Your comment on the Ashbourne project draft conditions

Query of stock (sheep) management and possible gate entrance in deleted lots 8 & 9 (now Solar farmland)

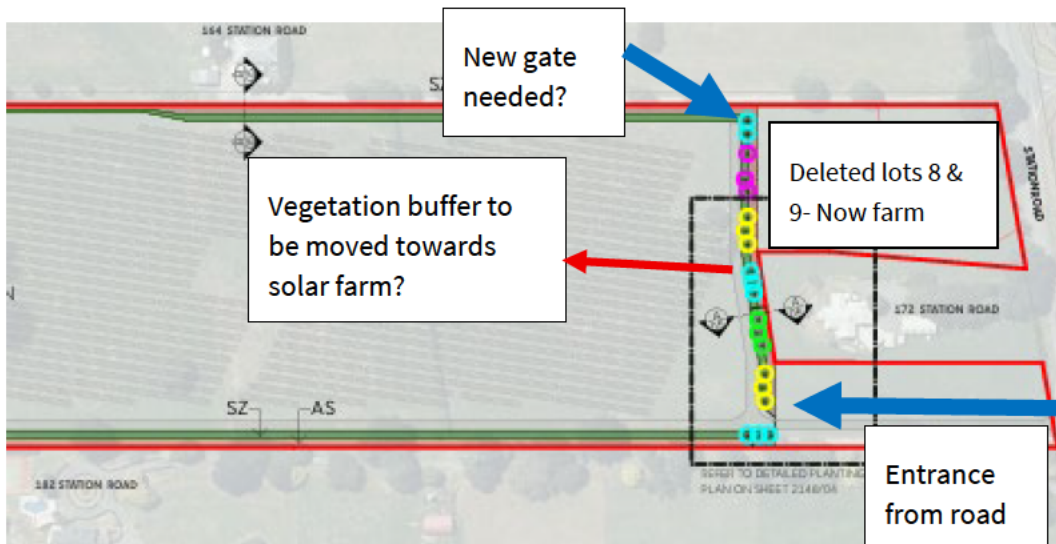
- 1.) The entrance way to the deleted lots 8 & 9 is still in the diagram on page 14 and 17 (see below). Can this please be confirmed if this is still here. I understand that only one this entrance is allowed on this farm lot 2 DP 567678.

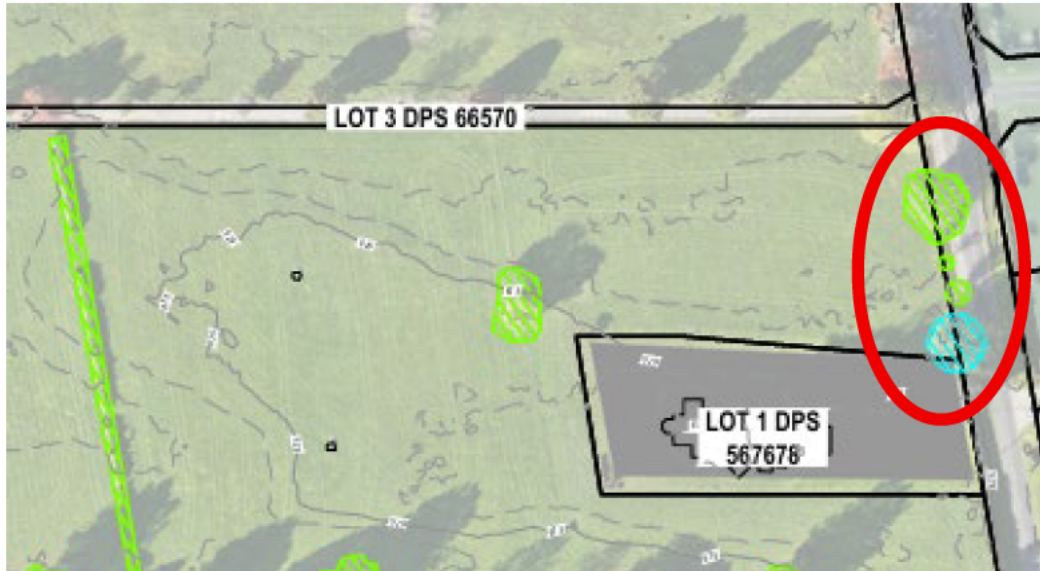
- 2.) If this gate /access is not allowed, how will the solar farm have access to the area that was originally lots 8 &9? The vegetation buffer goes up to the boundary of our section (lot 1)-see below. How are the stock going to have access to that bit of land? Will they have to put another gate from the solar panels to this area? Or will they need to push back the vegetation buffer towards the solar farm to provide an access road at the end of our property? I request that this be confirmed.
